RE: Follow Up to Request to modify the lane configuration on Master Plan of Arterial Highways (MPAH) Segment – Camino Vera Cruz.

RE: Request to modify the lane configuration on Master Plan of Arterial Highways (MPAH) Segment – Camino Vera Cruz.

ATTACHMENT 2

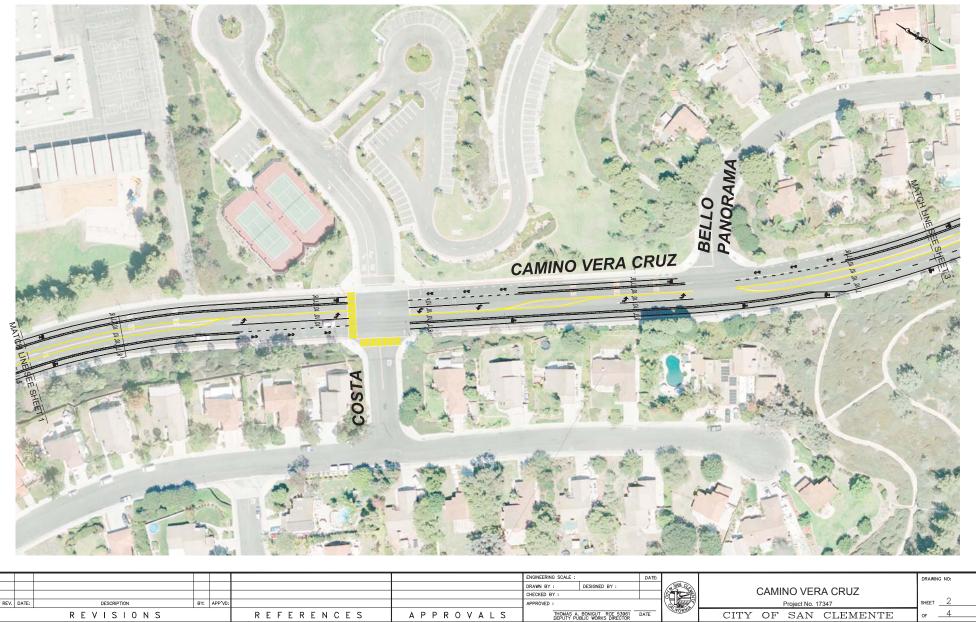
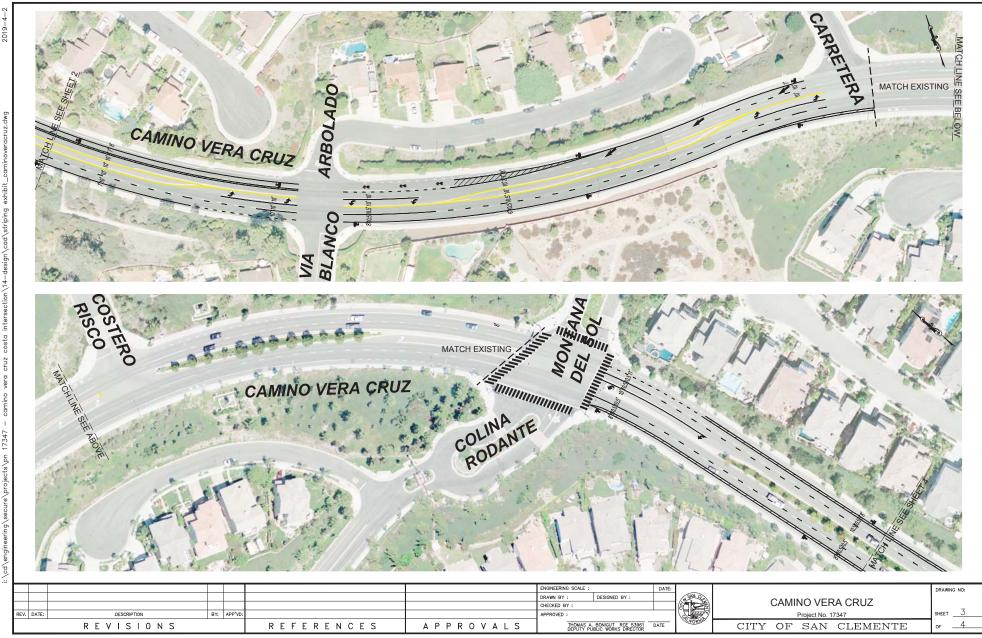
Camino Vera Cruz is a four-lane divided roadway from Camino De Los Mares to Avenida Pico, and is shown on the MPAH as a Secondary Arterial. The proposed lane reconfiguration is depicted in Attachment 2 and consists of the following:

- Maintain a 10-foot wide striped median with left turn lanes at intersections.
- Eliminate one vehicle lane in each direction from about Riachuelo to Carretera with appropriate lane drops, resulting in one 10-foot wide vehicle lane in each direction.

• Provide 8-foot wide parking lanes and buffered bicycles lanes (generally 2-foot wide buffer area with seven-foot wide bicycle lane) on both sides of Camino Vera Cruz.
